**CITY OF RICHLAND DEVELOPMENT SERVICES DIVISION
STAFF REPORT TO THE BOARD OF ADJUSTMENT**

PROPOSAL NAME: The Perch Restaurant Parking Reduction

FILE NO.: M2023-103

DESCRIPTION: Per RMC 23.54.080 requesting a 25% reduction to the restaurant off street parking requirements contained in RMC 23.54.020 by utilizing a joint use parking facility with the nearby Lulu's restaurant.

Figure 2: Proposed Parking Arrangement

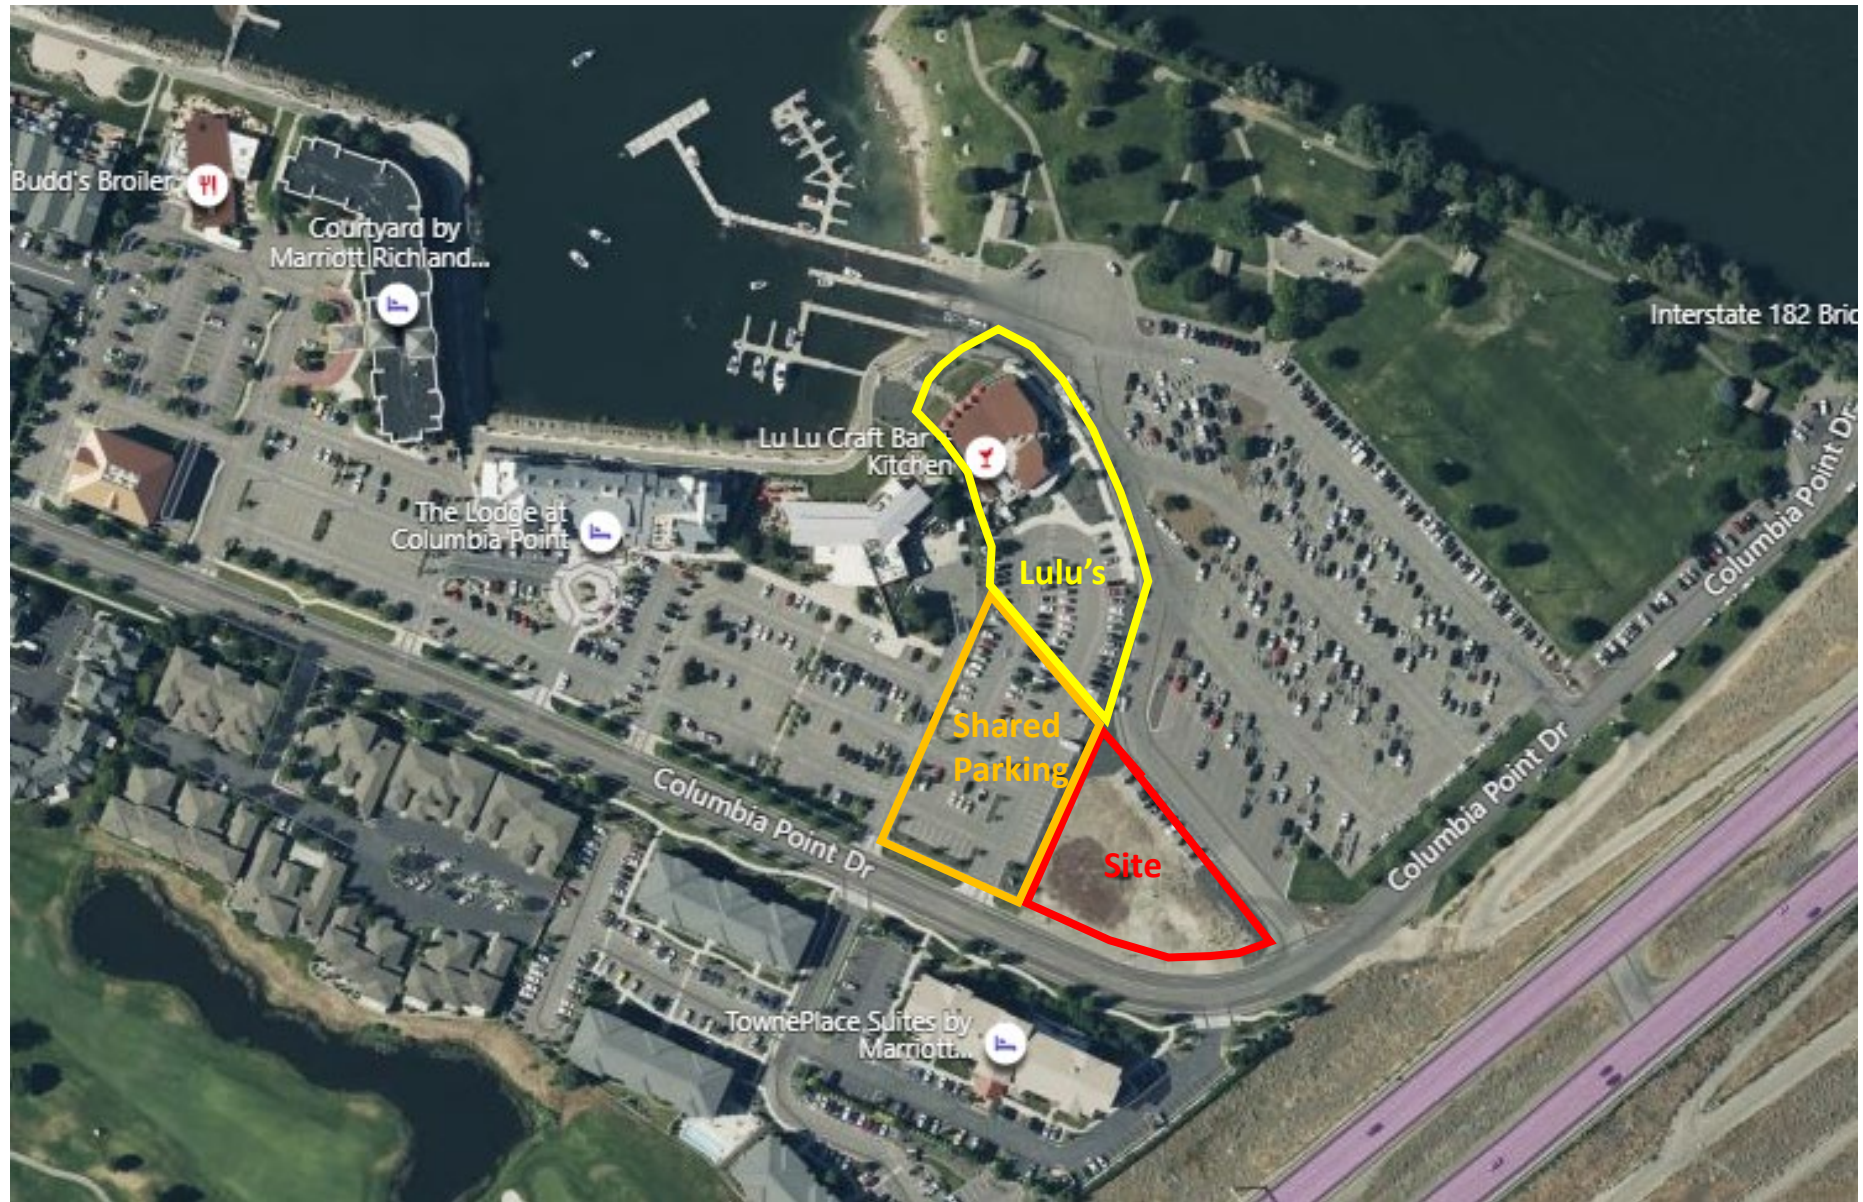
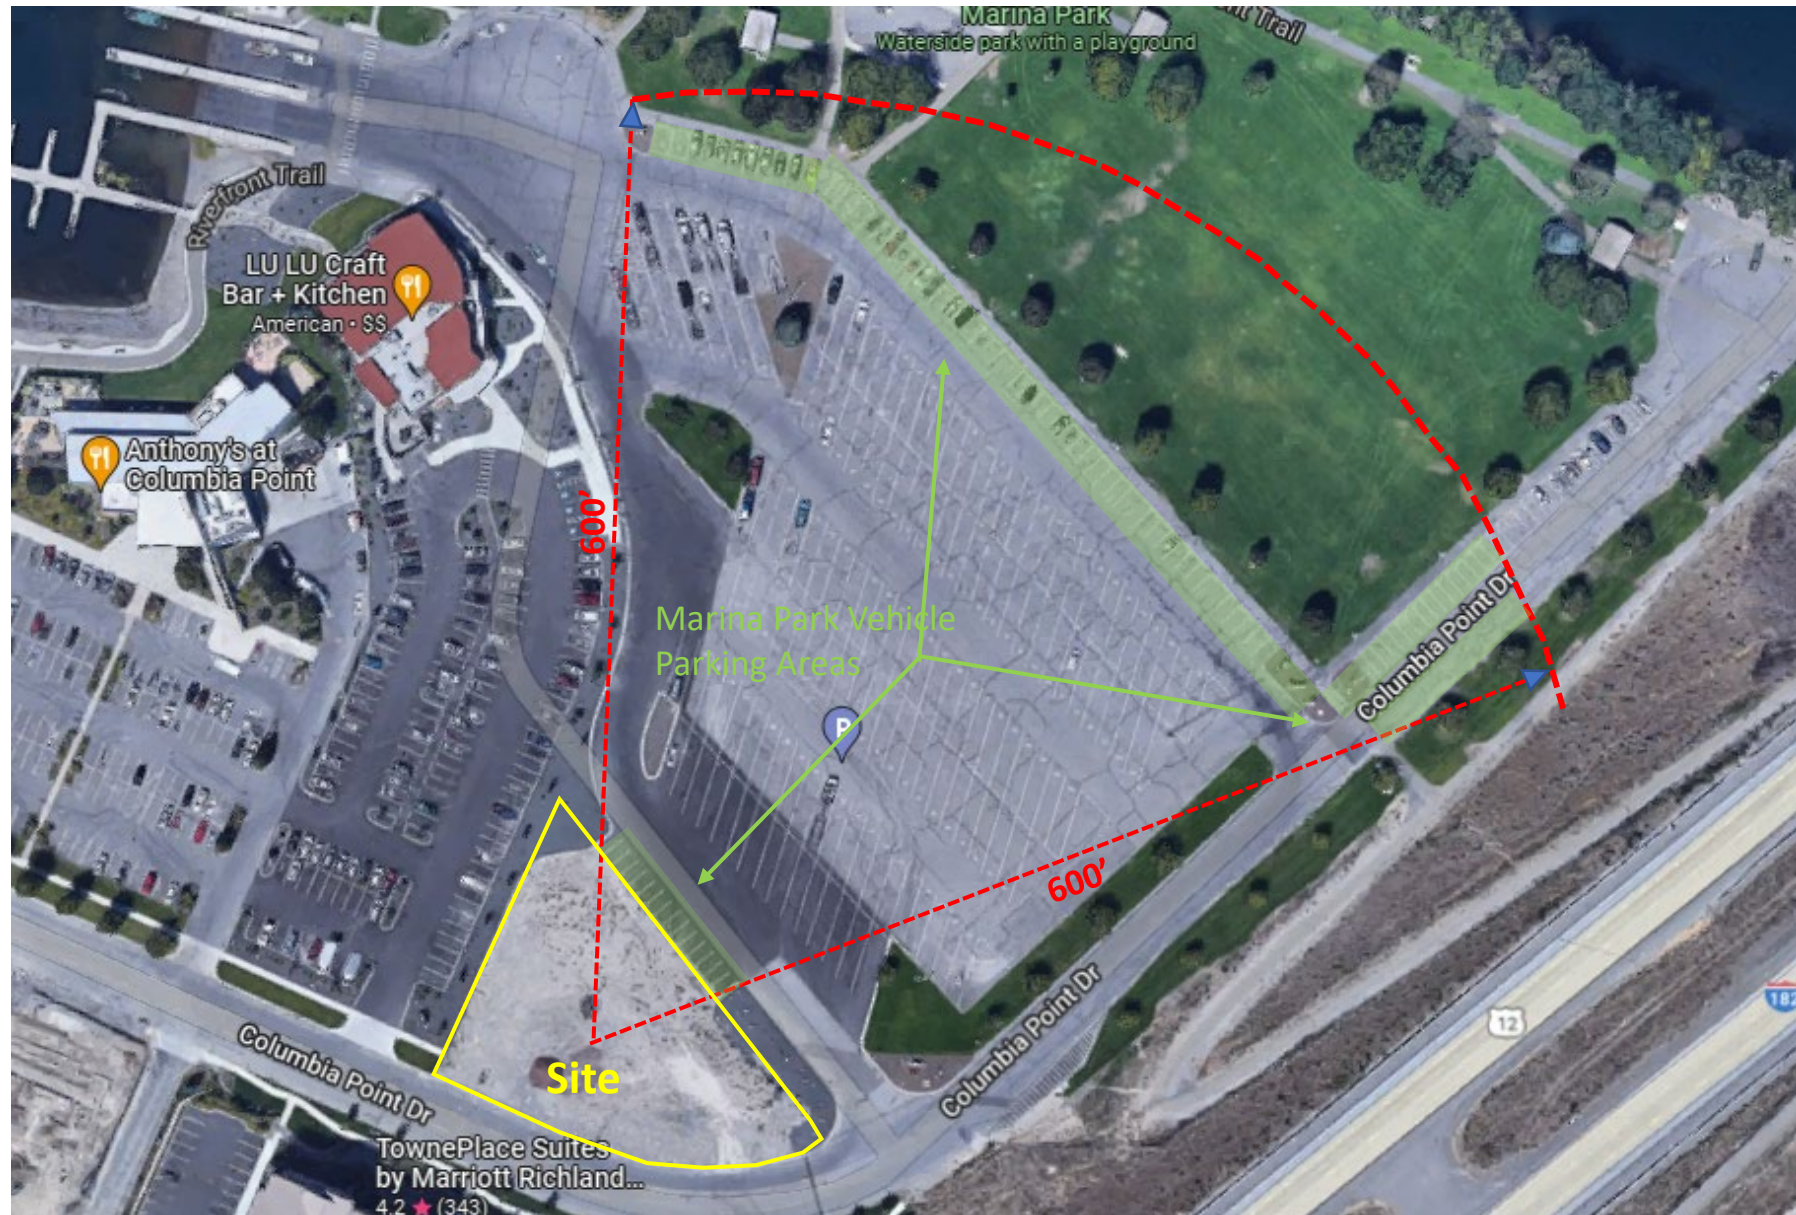
Our plans for the joint use parking facility would provide a total of 155 spaces. A 25% reduction in the total parking requirement would allow us to provide 146 spaces, which our plans would exceed by 9 spaces.

Figure 3: Potential Off-Site Parking Opportunities

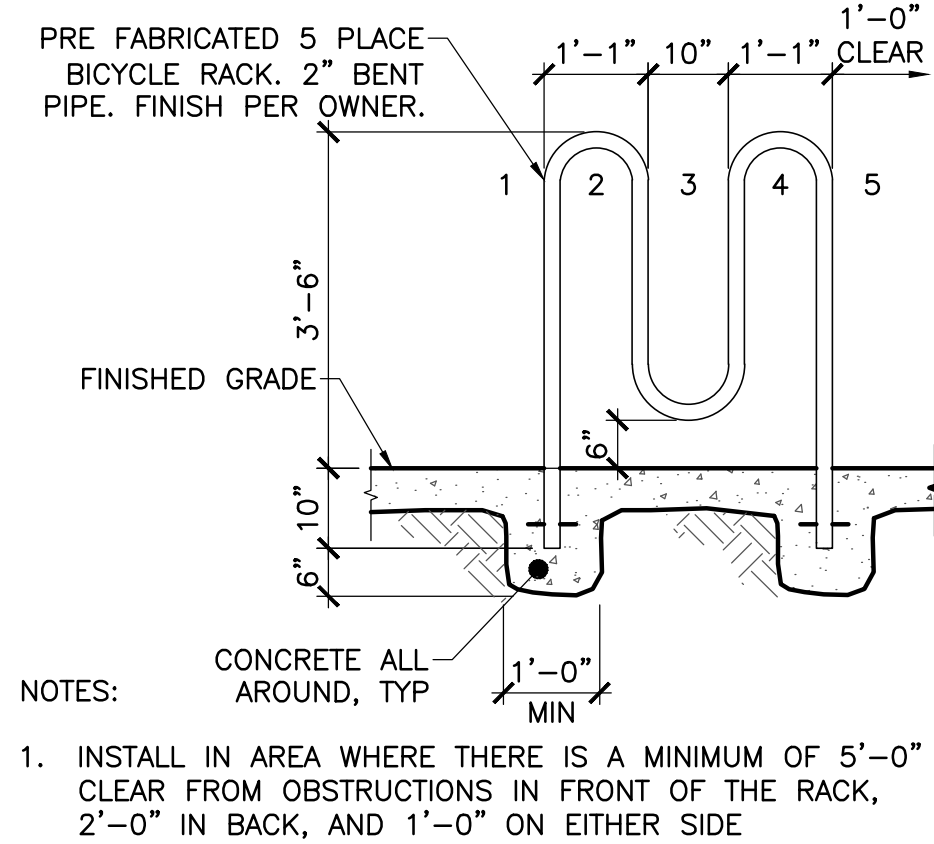
There are 116 parking spaces on the adjacent Columbia Point Marina property. (This is a count of vehicle parking spaces only, excluding boat trailer parking spaces.) All of these spaces are within 800 feet of both the existing Lulu’s Restaurant as well as our proposed “The Perch” Restaurant. This provides a huge number of additional parking spaces. Since the peak hours of restaurant operation are during the dinner hour, for much of the year, these parking spaces could be utilized after dark, when park use is minimal. (See attached Figure 3.)

Note: City code prohibits on-street parking along Columbia Point Drive, except east of the Marina Park entrance.
